Holder VAS6095/1-6

Holder VAS 6095/1-6 can be changed to VAS 6095/1-6a by cutting to size.

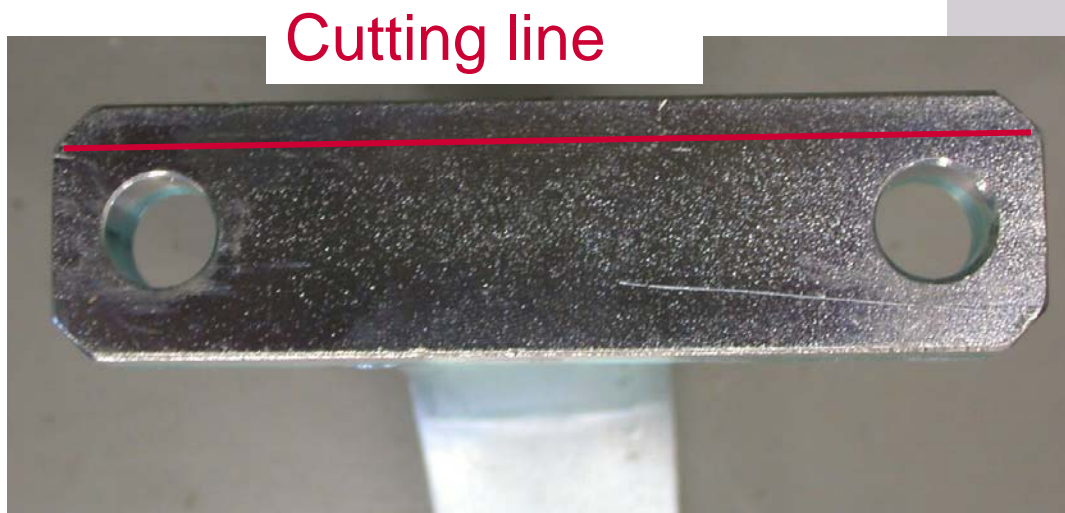
Cut 4.5 to 5 mm off upper side of holder VAS 6095/1-6.

Height of holder -6 = 30 mm
Height of holder -6a = 25 mm
